RANE

ME 30 ASSY

522.020

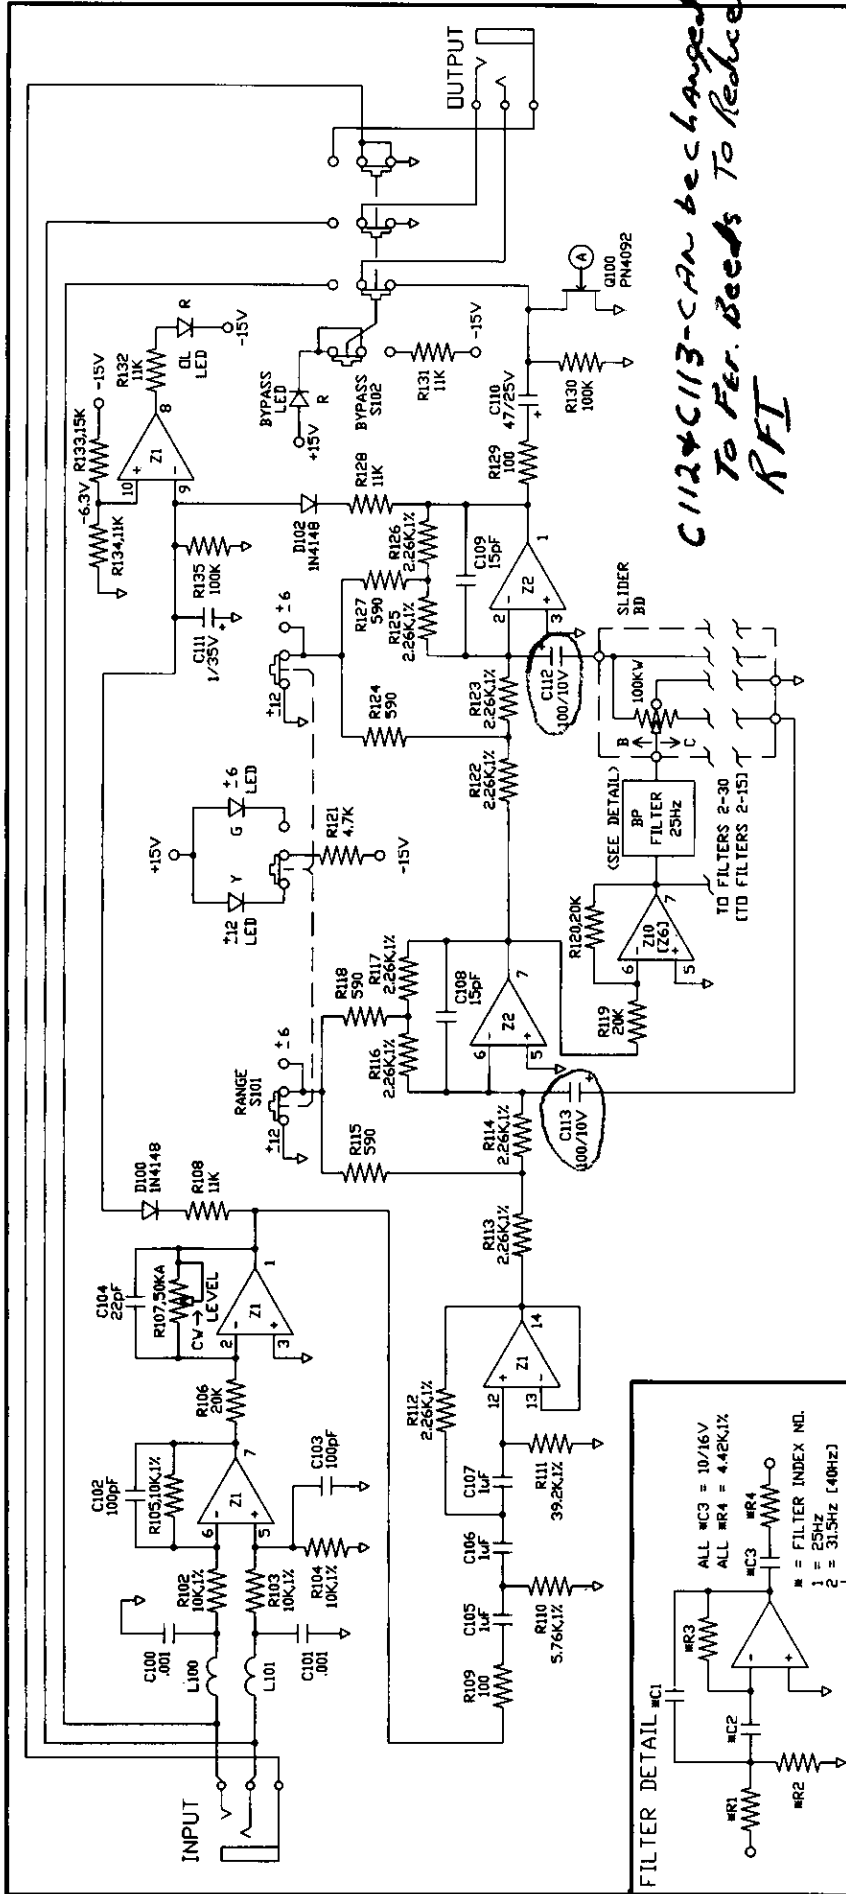
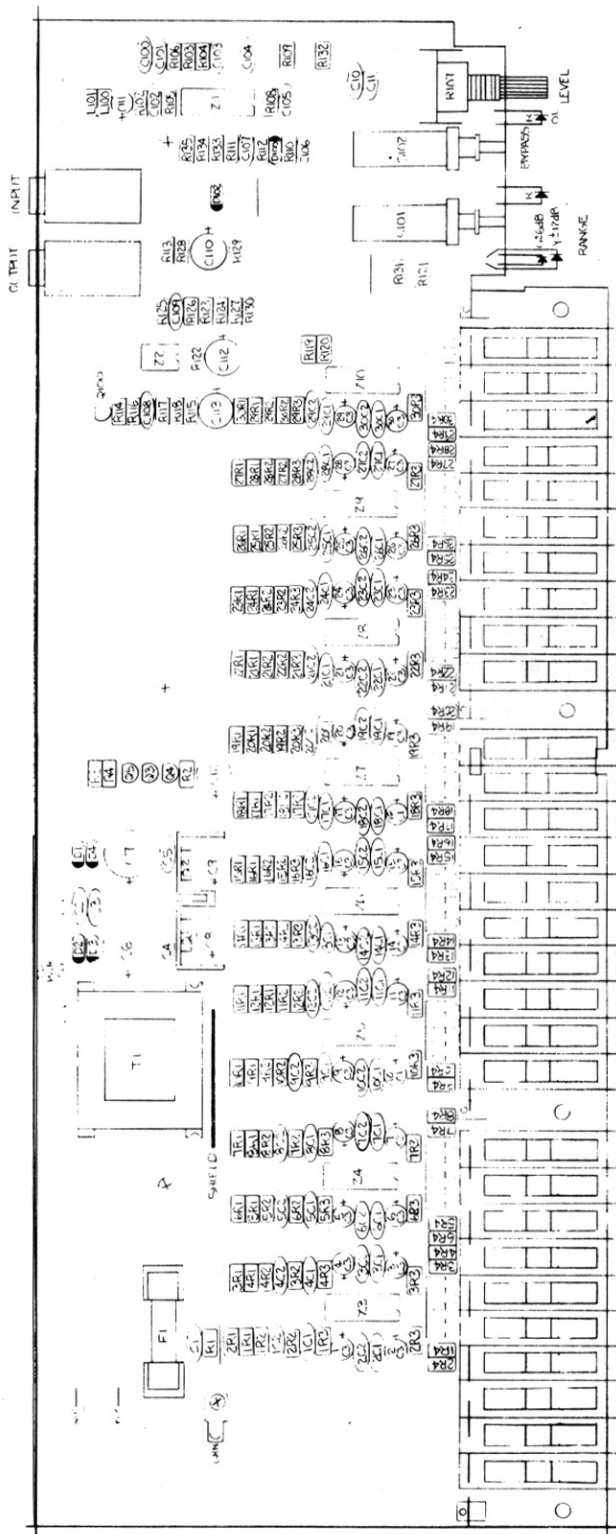
*C112 & C113 - can be changed
To Ferr. Beeds To Reduce
RFI*
